Re: Recommendation to Approve Amendment No. 2 (AM-02) with Objection, Brannan Sand and Gravel Company, L.L.C., Pit 29, DRMS Permit No. M-1980-183

**Re: Rationale for Recommendation to Approve a 112c Application Reclamation Permit,
Amendment Application No. 2 (AM-02) with an Objection,
Pit 29, DRMS Permit No. M-1980-183**

RE: Brannan Sand & Gravel Company Pit 29, Permit No. M-1980-183, Amendment to AM-02,
Datum Shift

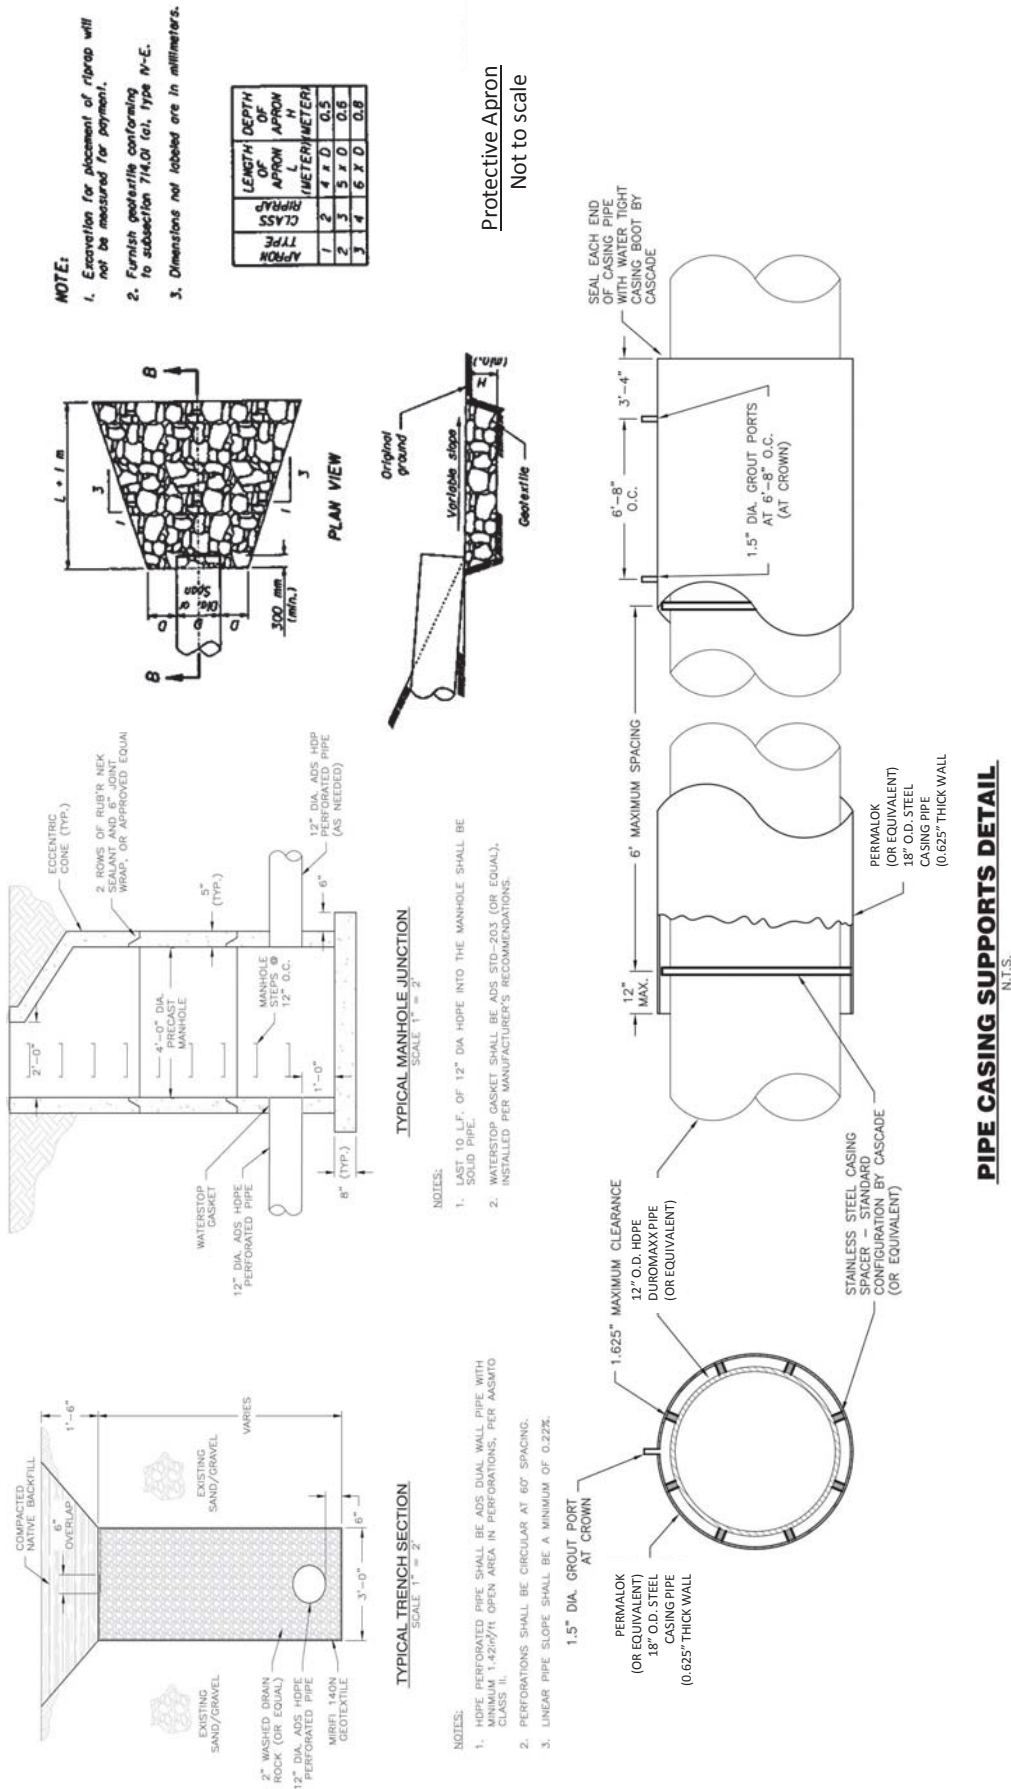
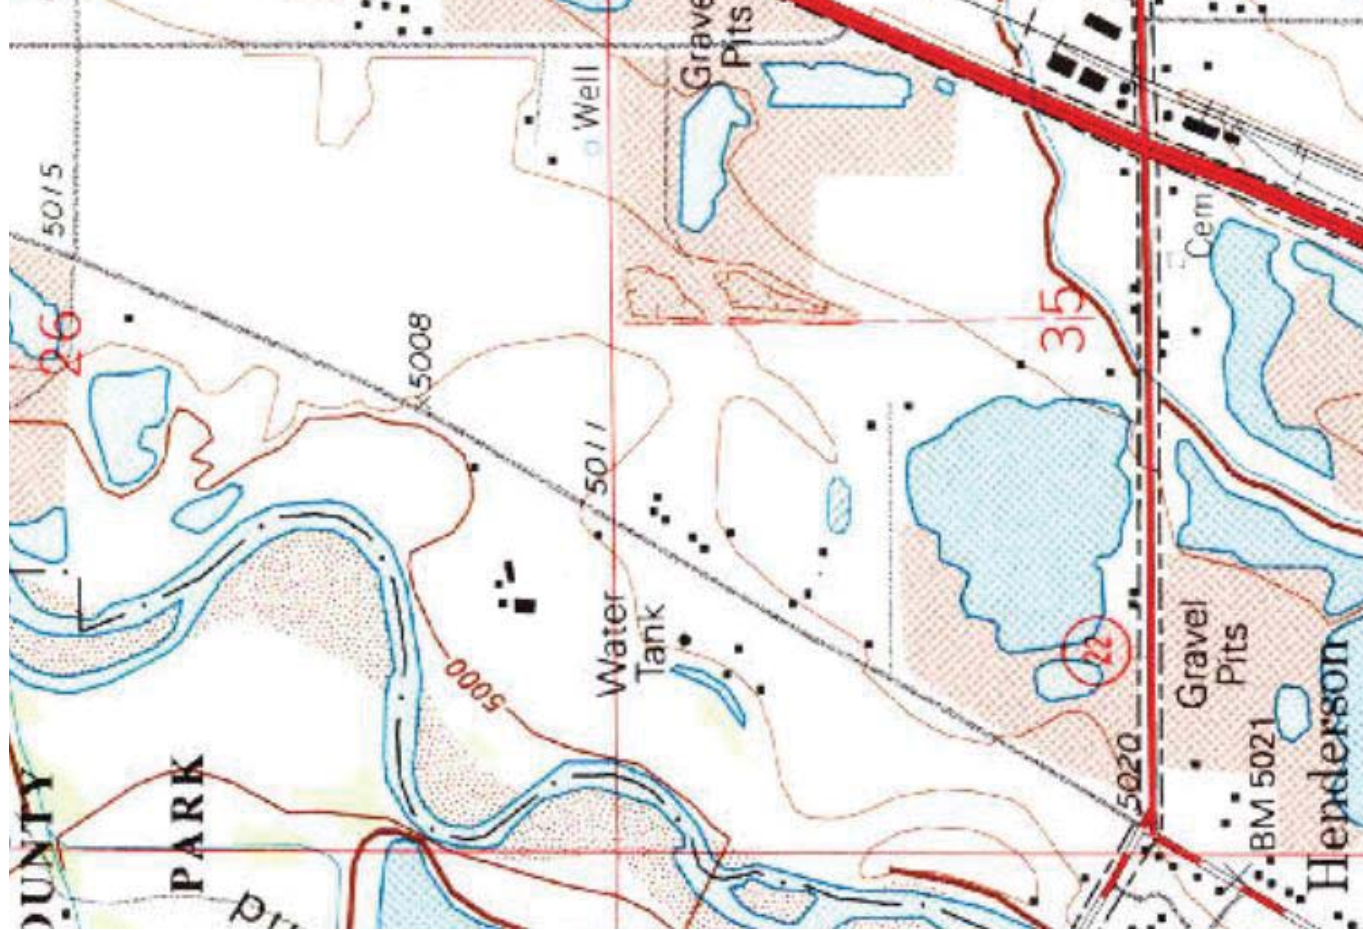
This tool converts NGVD 29 to NAVD88. Using a NGVD29 datum (1965 map) of 5005 feet, the tool result is a NAVD88 datum of 5007.878 ft. Attached is the print of the result.

Based on this conversion, our drain elevation of 5007' at the west end is accurate and would replicate the historic ground water level. Datum conversion using the VERTCON tool is appropriate for the purposes of correlating this groundwater data. Attached is a revised Exhibit E adding a NAVD88 datum note.

BRIGHTON, CO
39104-H7-TF-024

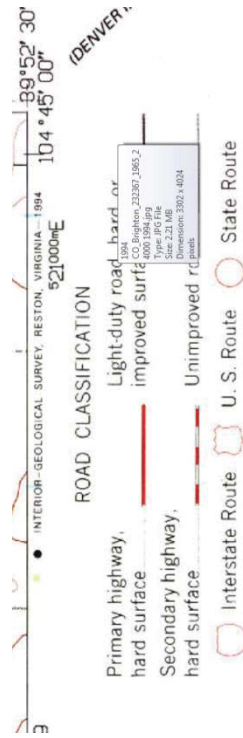
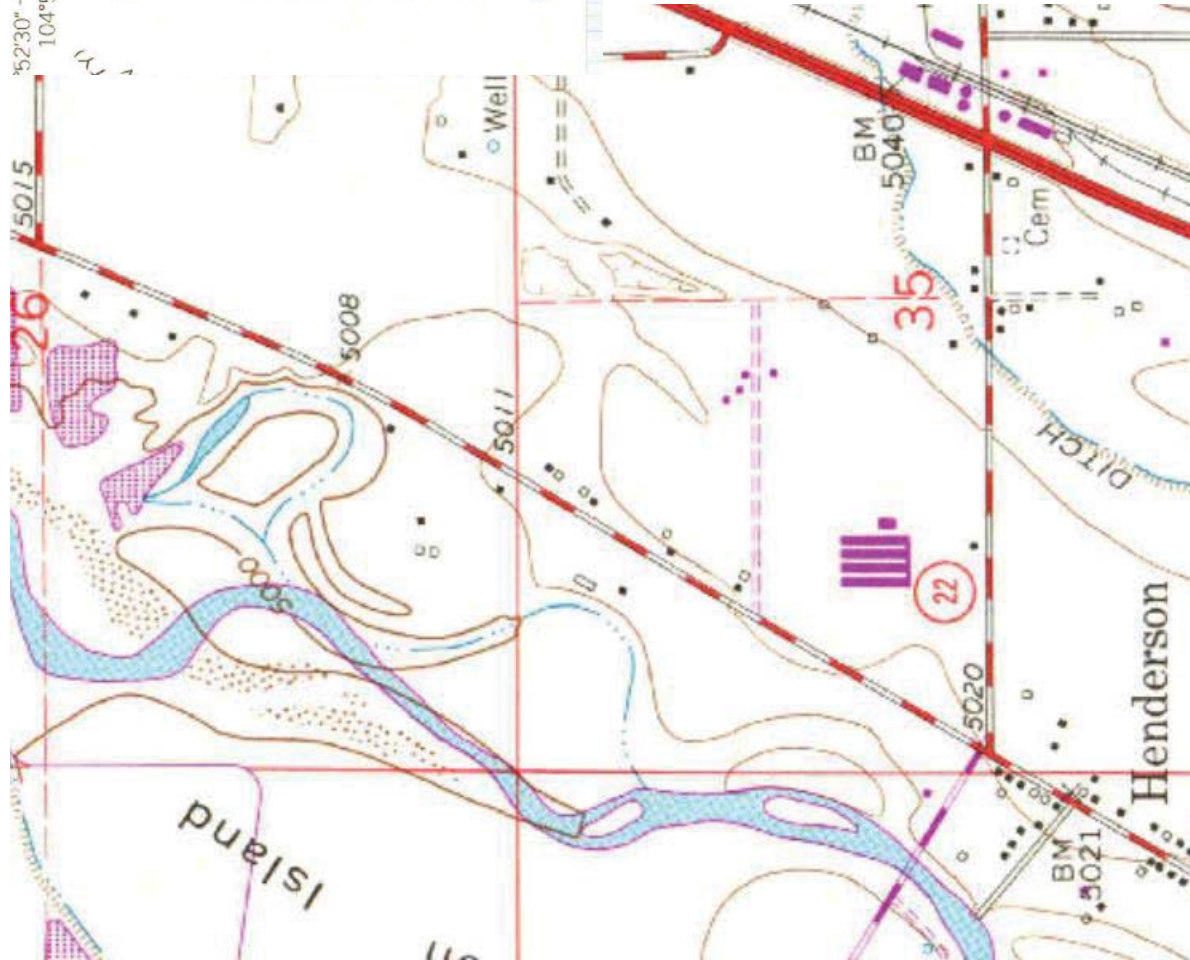
The topographic map in use in 1980, when the water level contour map was made and included in the original Brannan Pit 29 application, was dated 1965 (photo revised 1979). That map was revised in 1994. Therefore the 1965 map was the one in use in 1980. A copy of the legends of both maps is attached. The vertical datum in use in 1980 was NGVD29.
